RECEIPT DATE: 7/5/18 **ONSITE SEWAGE DISPOSAL SYSTEM** P 563048  
 APPROVAL DATE: 7/26/18 gsc **PERMIT: CONSTRUCTION** A \_\_\_\_\_

PROPERTY ADDRESS: 1040 Fairlane Road

**RE:** 1040 Fairlane Road  
Fairlane Farms, Lot 22

The OSDS Plan for 1040 Fairlane Road has been reviewed with the following comments:

**SEPTIC SYSTEM INSTALLATION SITE PLAN**  
**LOT 22**  
 1040 FAIRLANE ROAD  
**FAIRLANE FARMS**  
 PHASE TWO  
 ZONED: RC-DEO  
 TAX MAP NO.: 8 GRID NO.: 2 PARCEL NO.: 8  
 5TH ELECTION DISTRICT HOWARD COUNTY, MARYLAND  
 SCALE: 1" = 30' DATE: MARCH 8, 2018  
 SHEET 1 OF 1

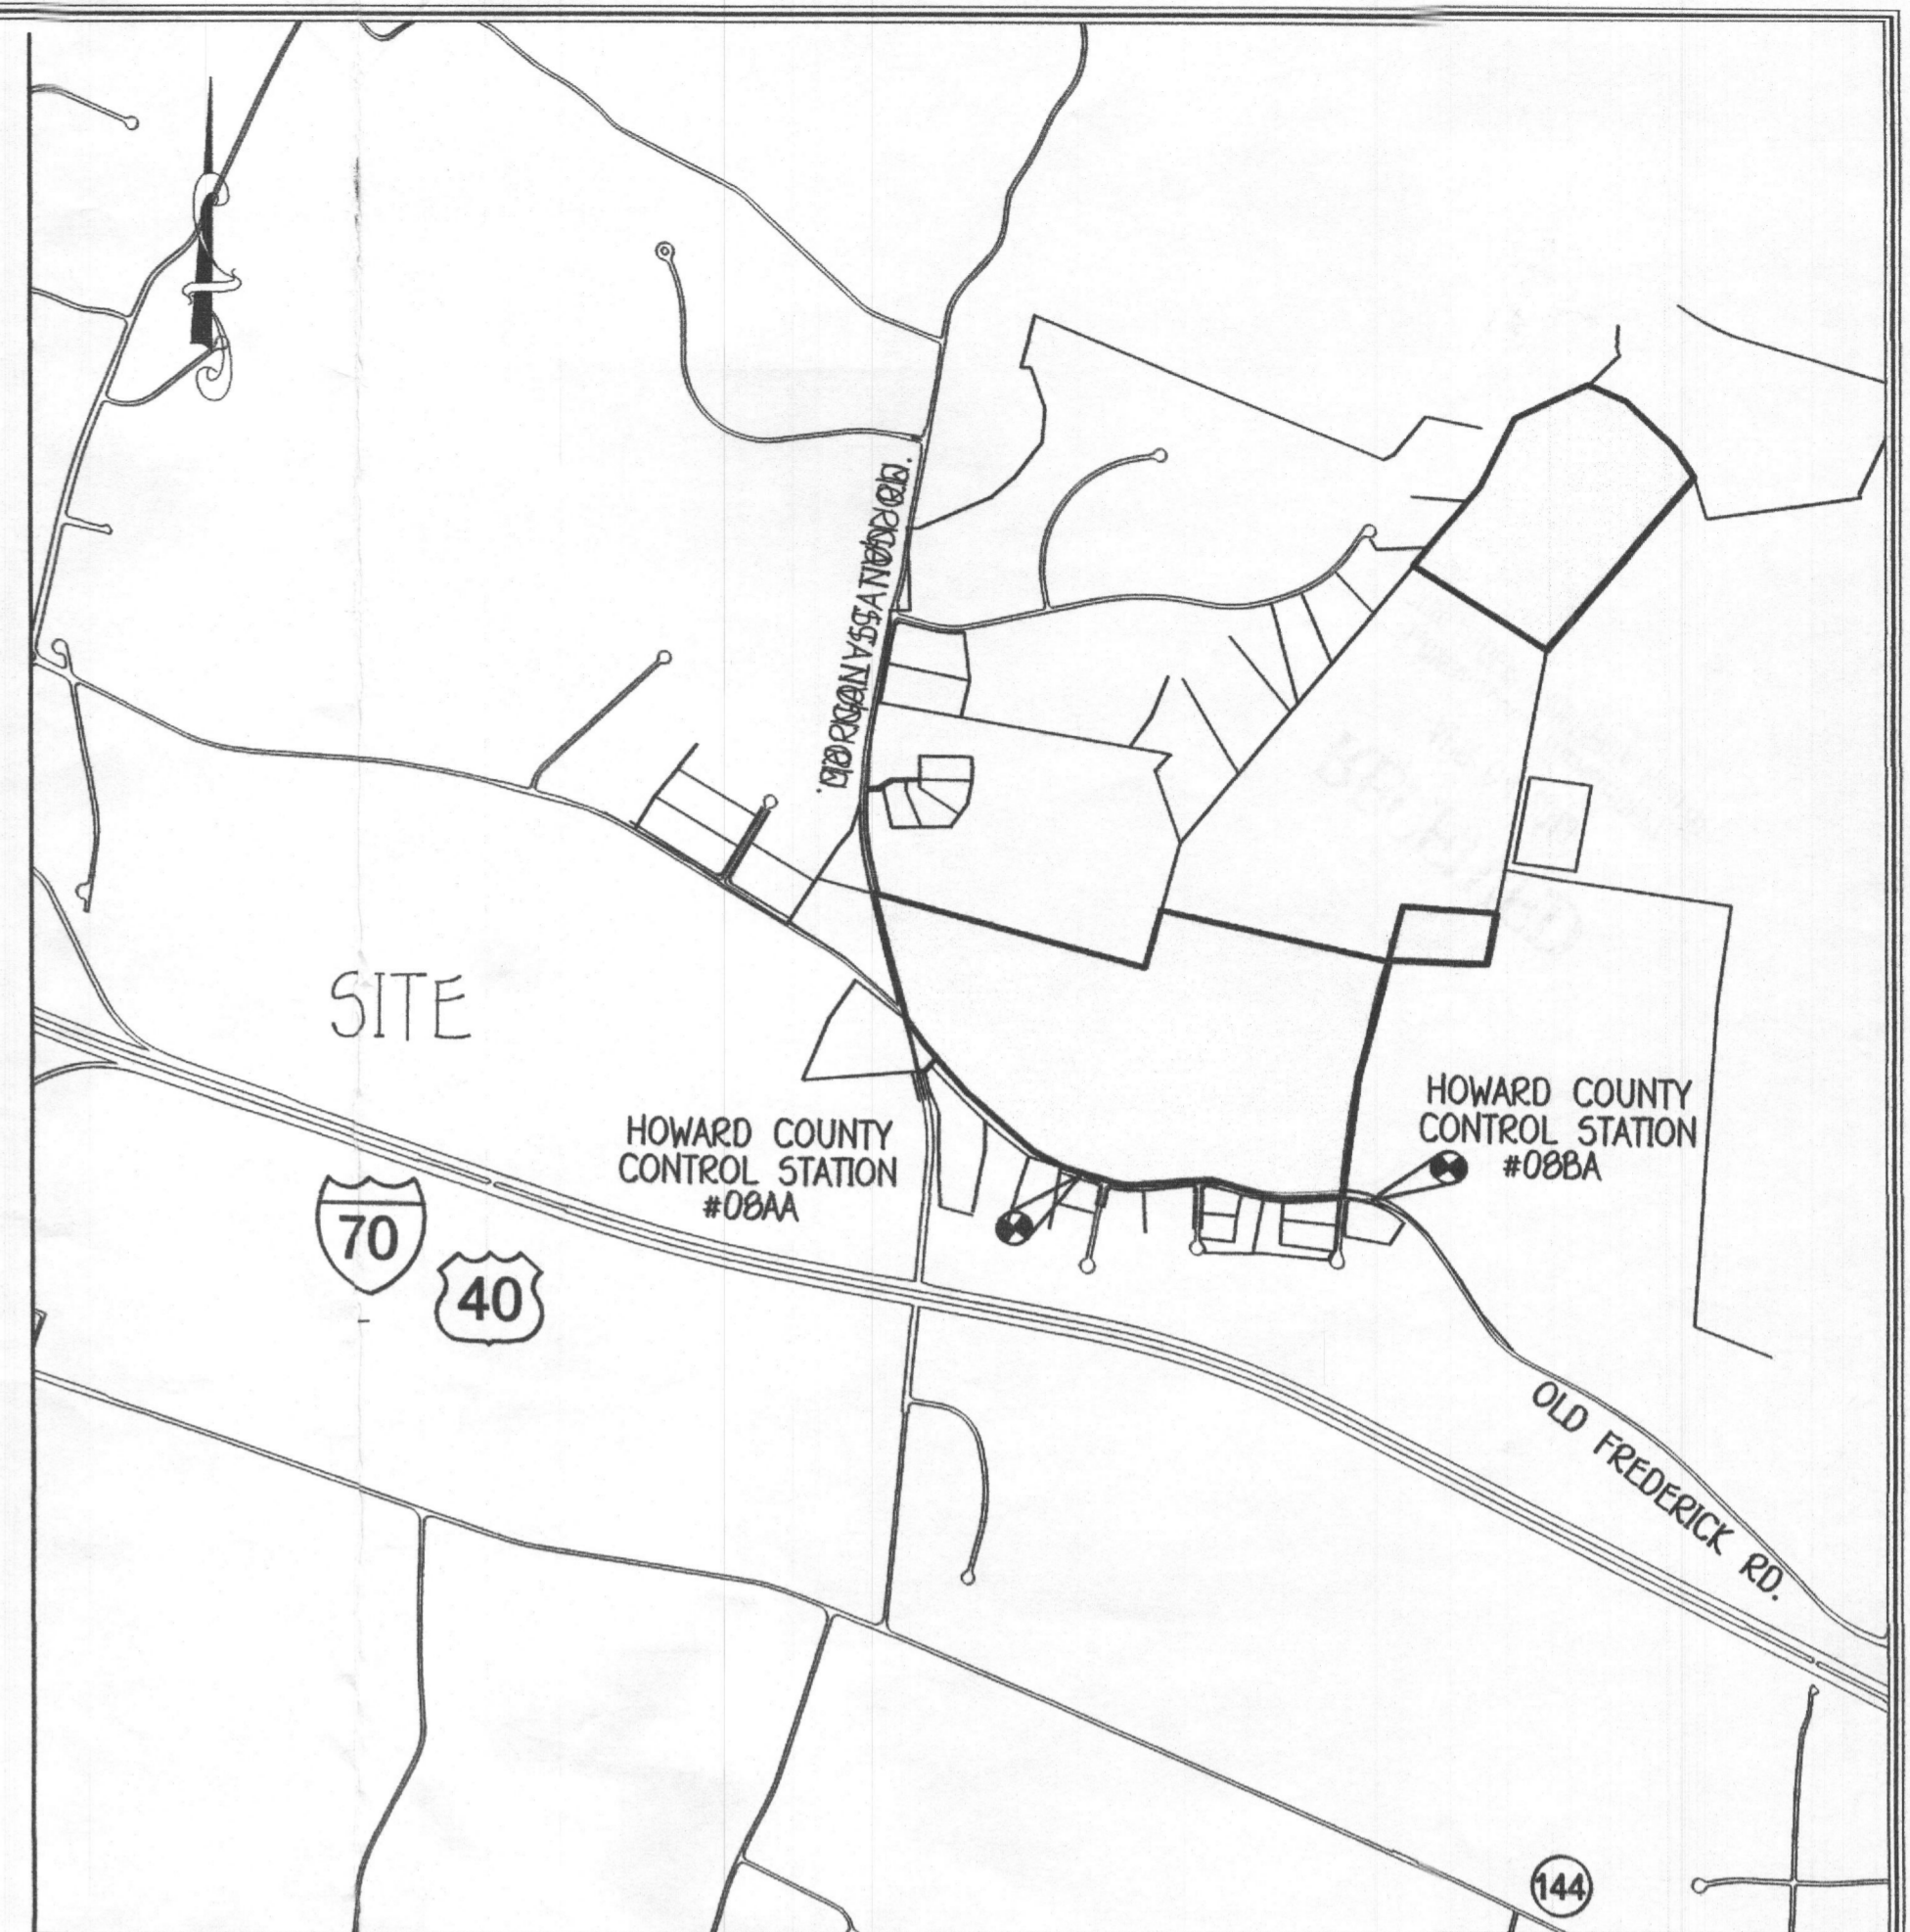
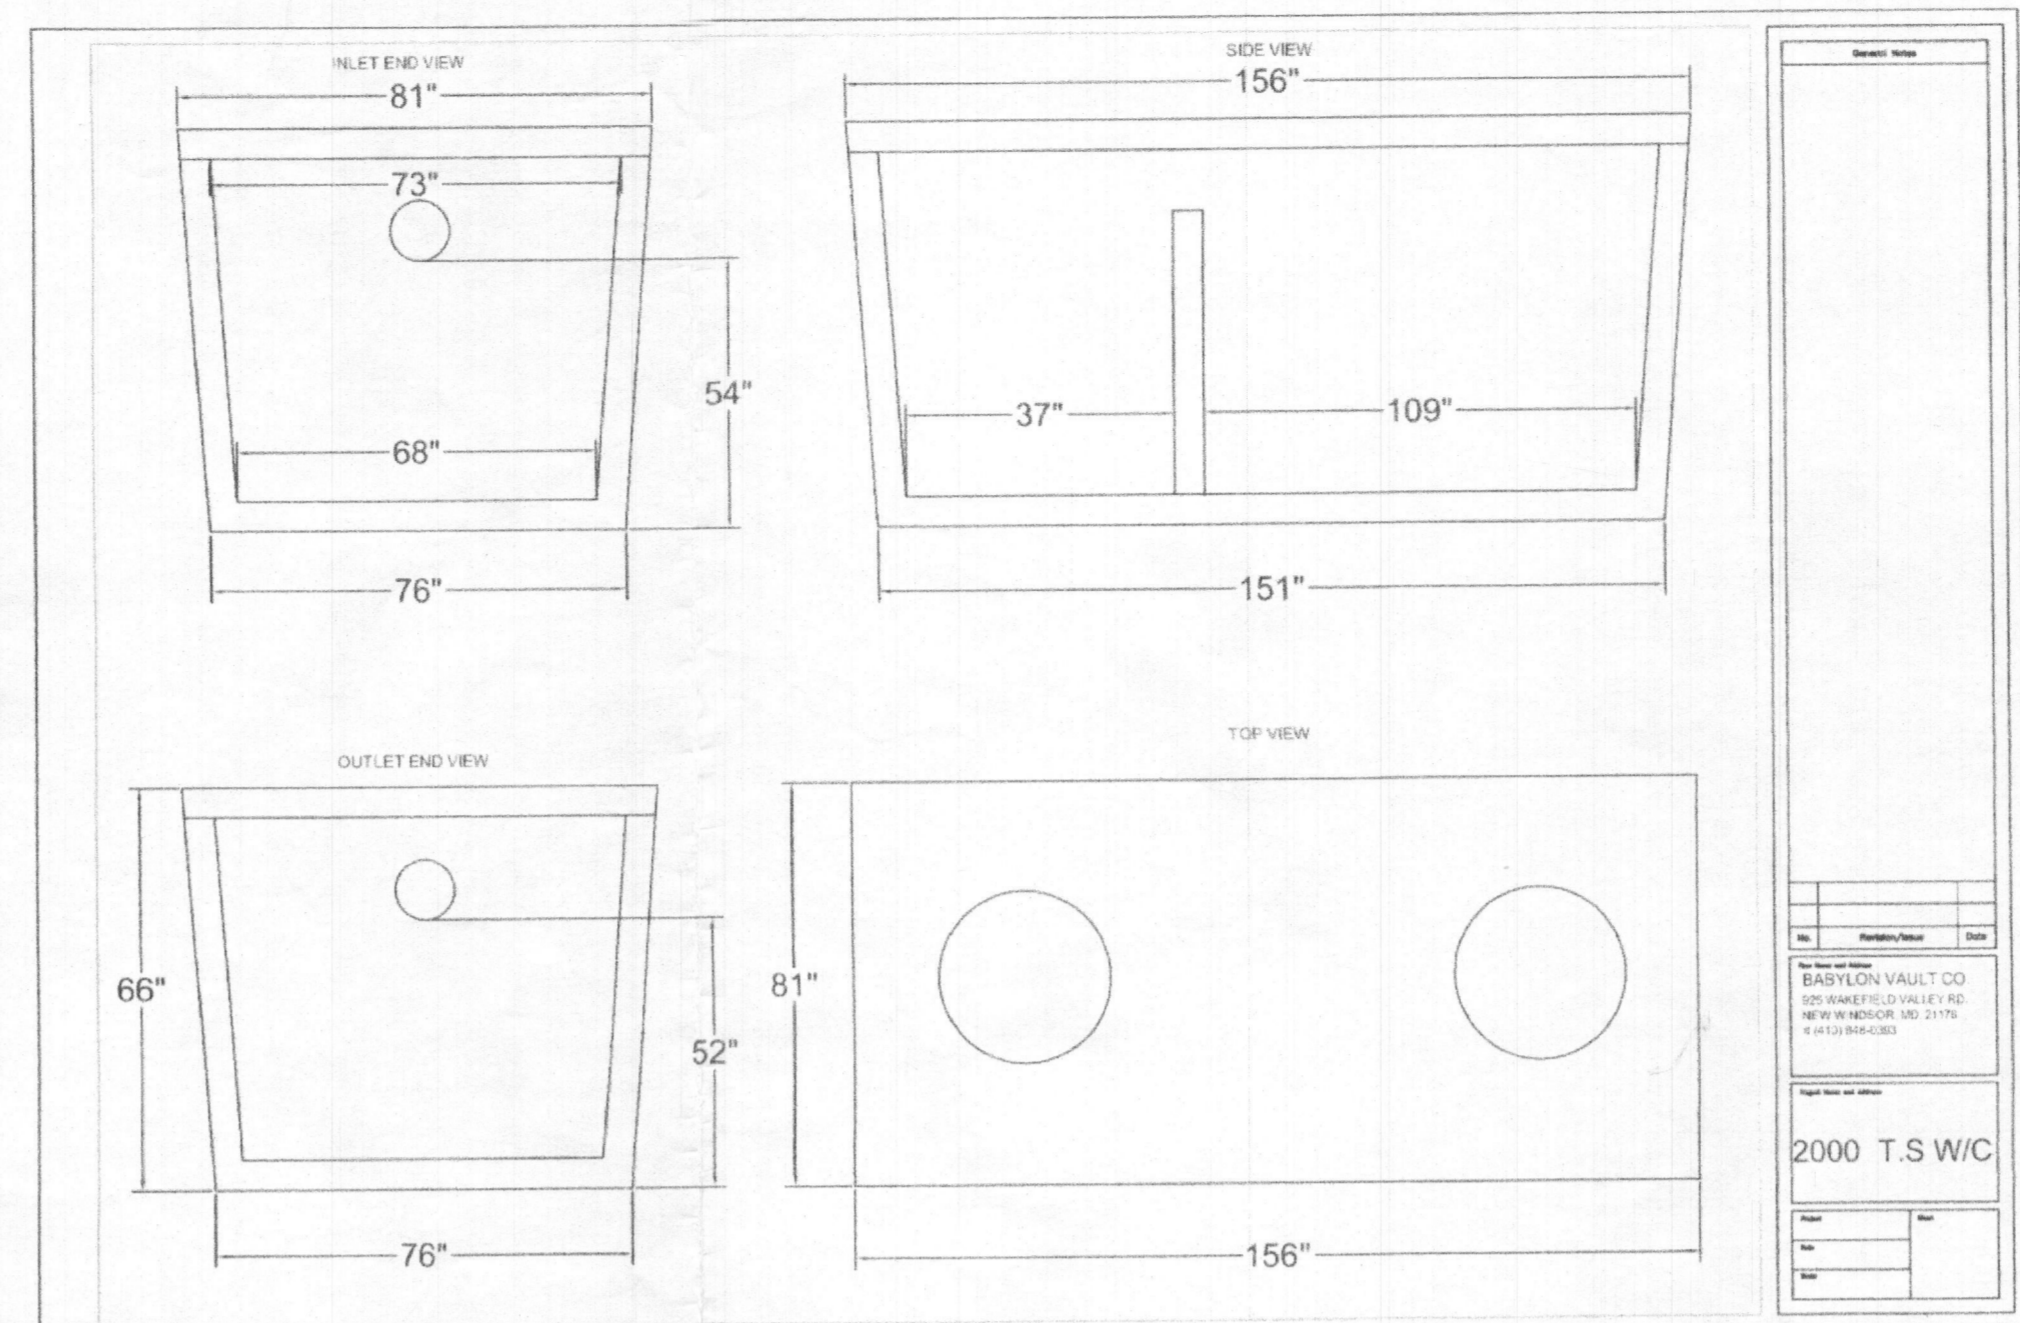
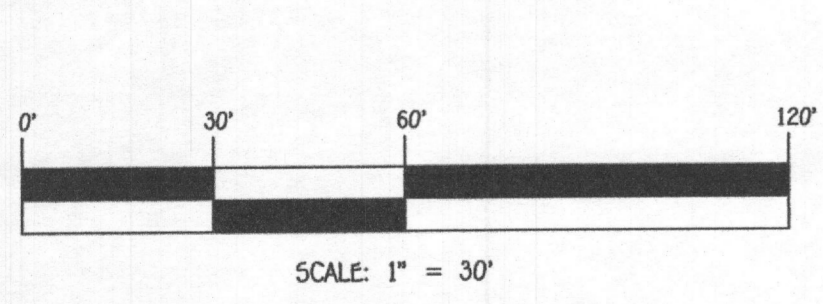
For the future storm water management pond next to Lot 22, we would like to see the 25 foot setback from the 580 line because that's where the outflow is located (See attachment). As a reminder, if you have to revise the SDA, then a revised perc cert will be required.

- 1.) For 5 foot of side wall credit, raise invert up to 3 feet, and change trench data plus trench detail to reflect.
- 2.) Change trench layout for 1<sup>st</sup> and 2<sup>nd</sup> replacement to reflect proper lengths on plan
